SANITARY SEWER

"AS BUILT" 11-26-02 E. Ruggles + Bohm

Hamilton Middle School
Sewer Line 1
Wichita, Kansas

PROJECT NUMBER
1210 PPS (607861)

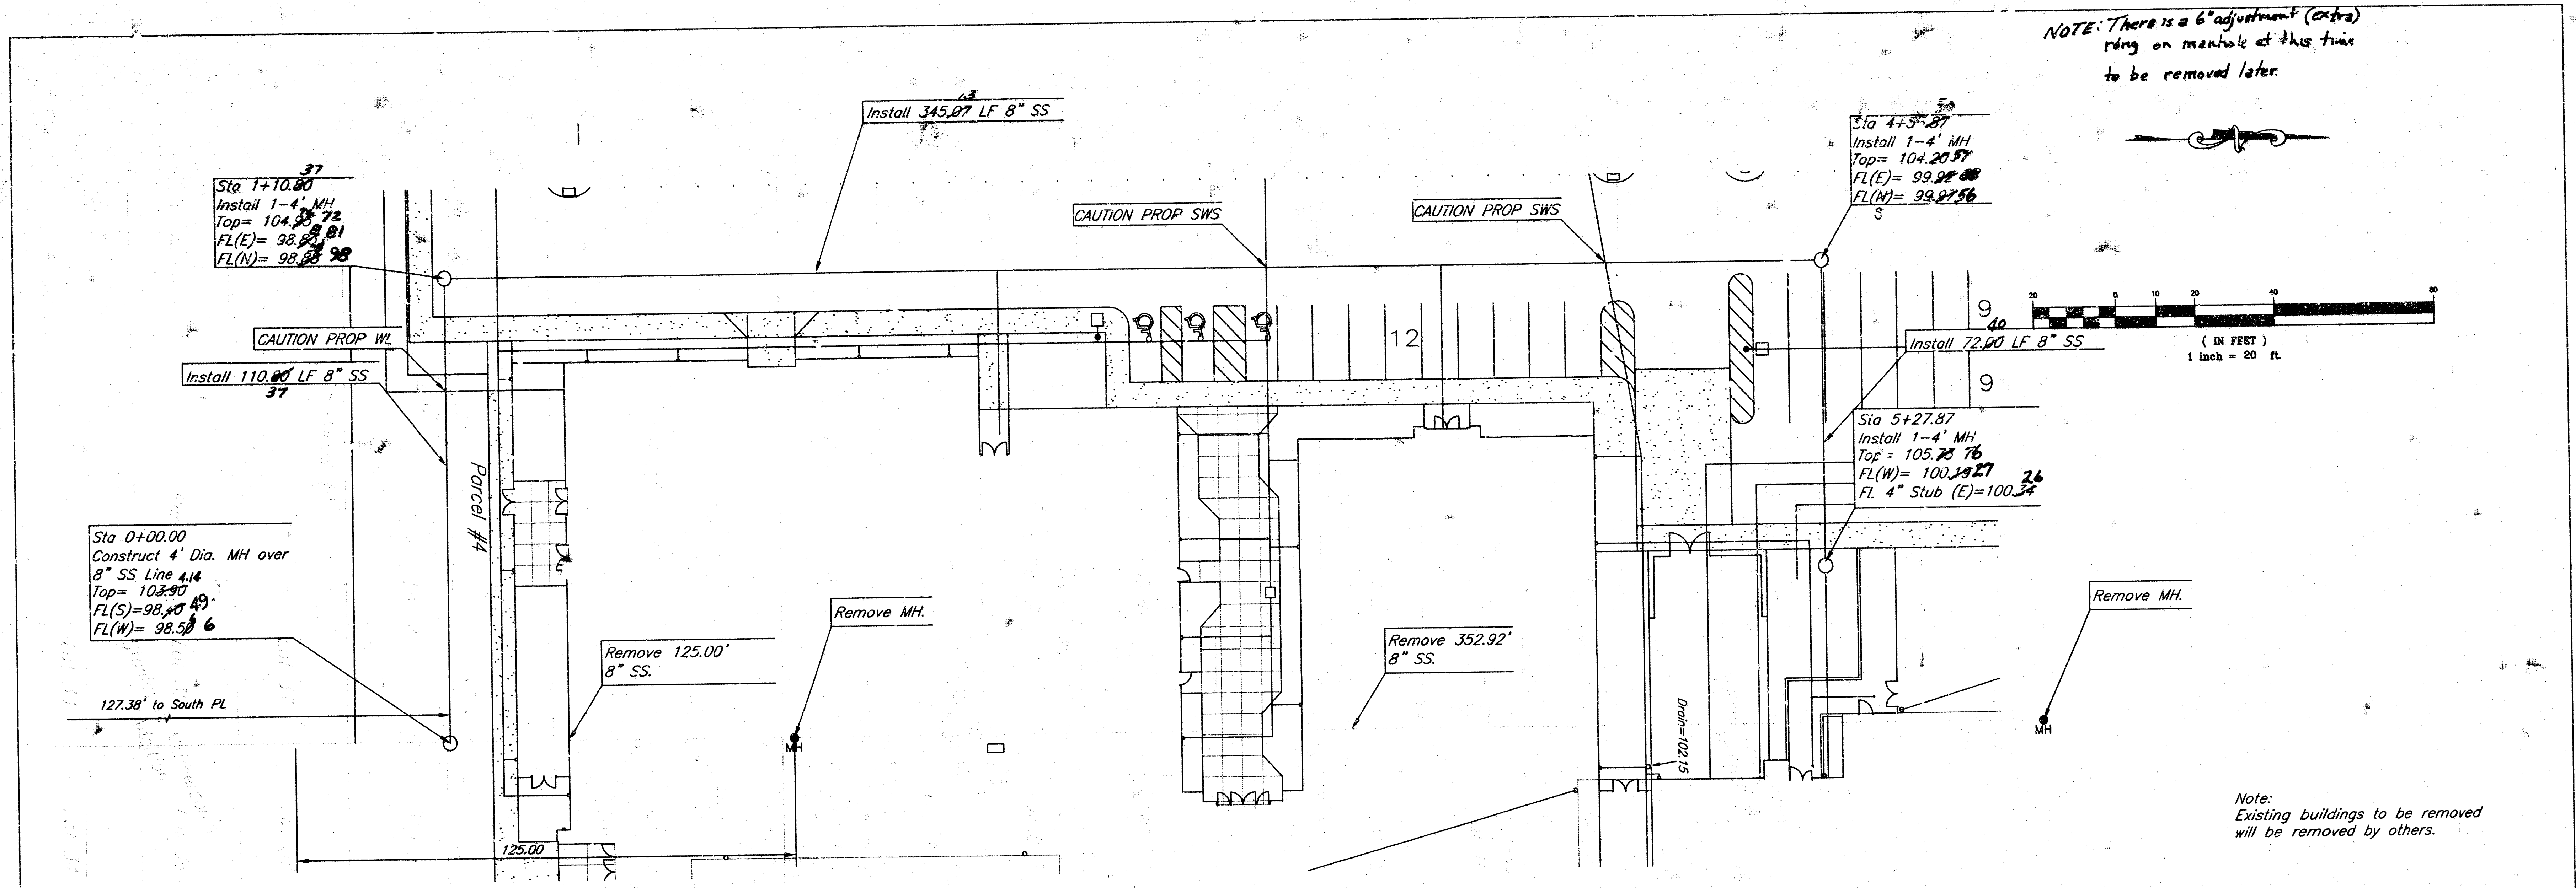
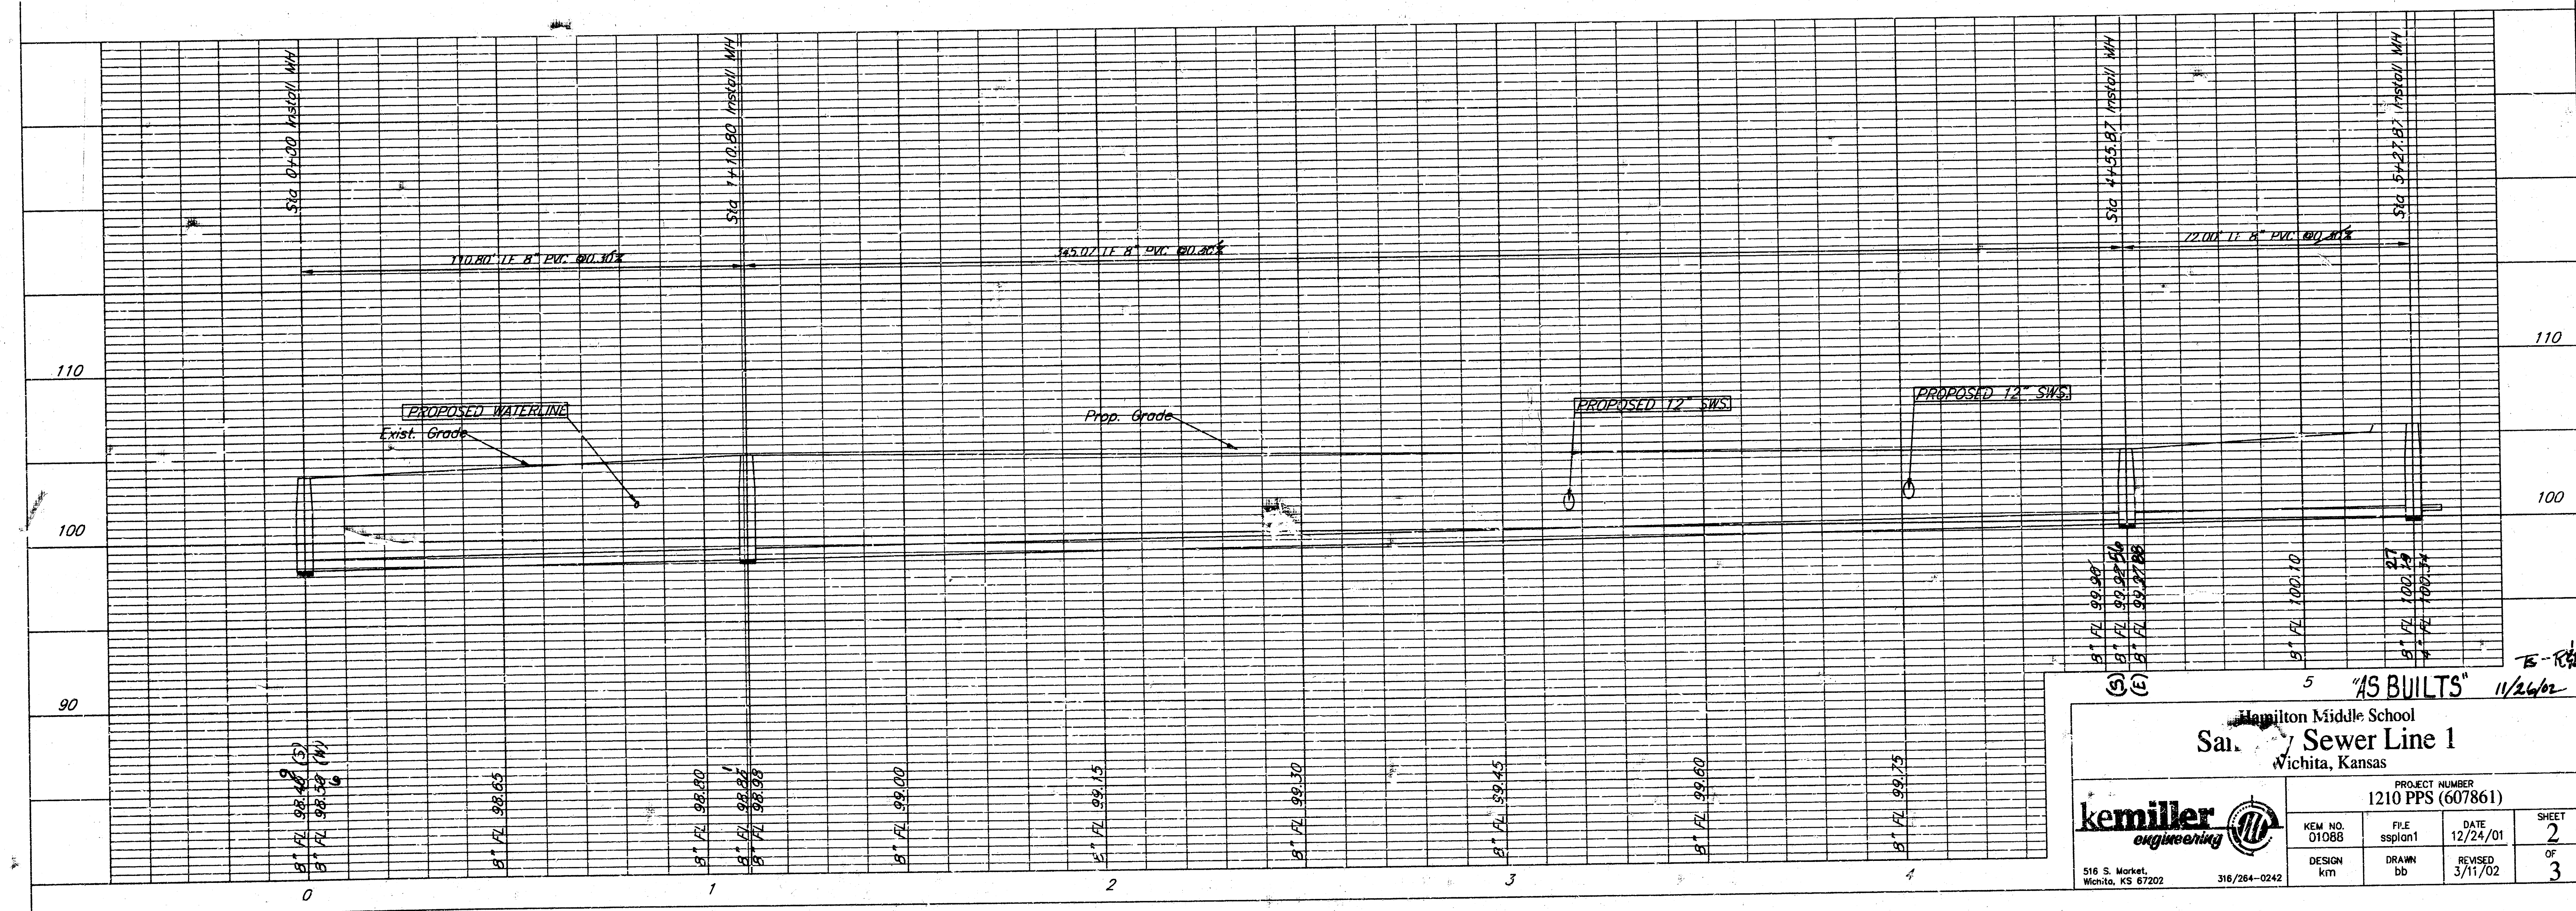
pipe used SDR35
 MH by W.C.P.

NOTE: There is a 6" adjustment (extra) ring on manhole at this time to be removed later.
